SIB 52 09 20

2023-10-20

**HEAD RESTRAINT AND/OR BACKREST OF 3RD ROW SEATS CANNOT BE FOLDED DOWN**This Service Information Bulletin (Revision 6) replaces SI B52 09 20 **dated August 2023**.**What's New:**

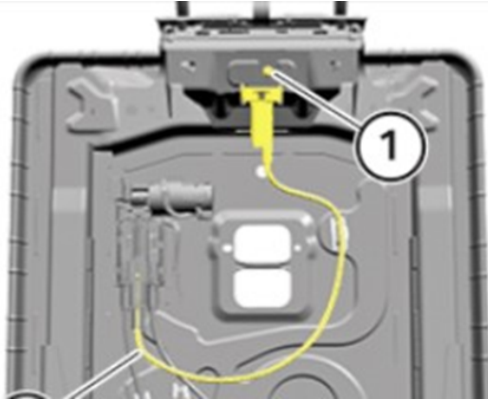
Can the head restraint be manually unlocked using the release loop beneath the headrest (see picture) and thus folded down?

**YES** = Head restraint mechanism is faulty. Determine root cause of Bowden cable not moving (see steps below). If the cable is moving fully but the headrest is not folding, then replace the folding module of the head restraint (#2 in picture).

See REP 52 30 118 Remove and install/replace folding module of left or right head restraint

**NOTE:** The head restraint cannot be removed without destroying the covering material. **A new cover (leather) will be required to perform this repair.**

### Cable routing UP TO February 2023 shown.

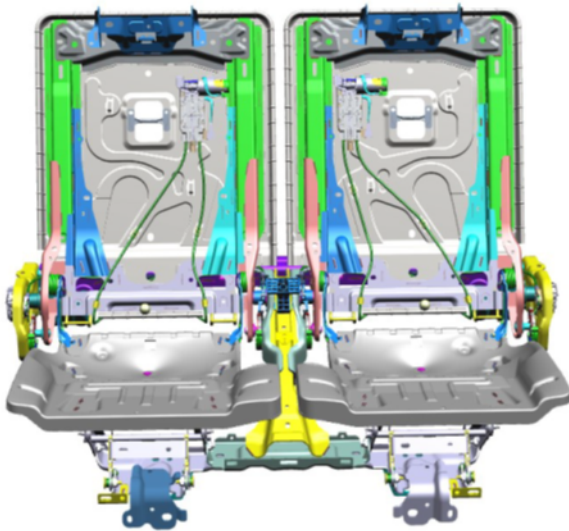
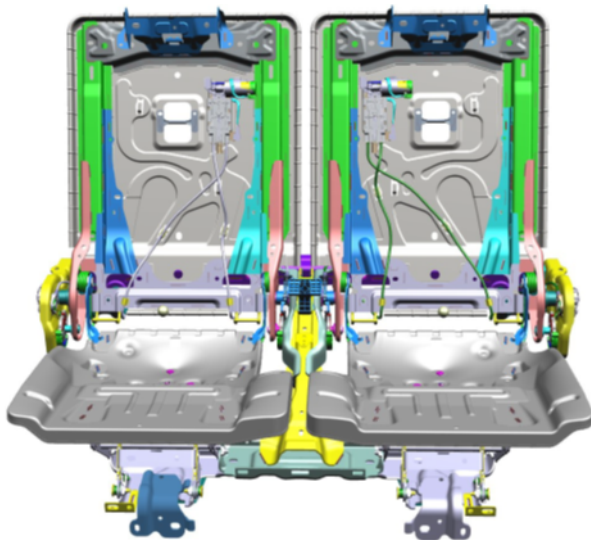
**NOTE:** A Bowden cable routing change was made in the third seat row backrest. This change was implemented starting in February 2023 production.

Replacement parts are all the new shortened design cable and require a new routing to install in vehicles produced prior to February 2023.

See Service Bulletin **B52 14 23**
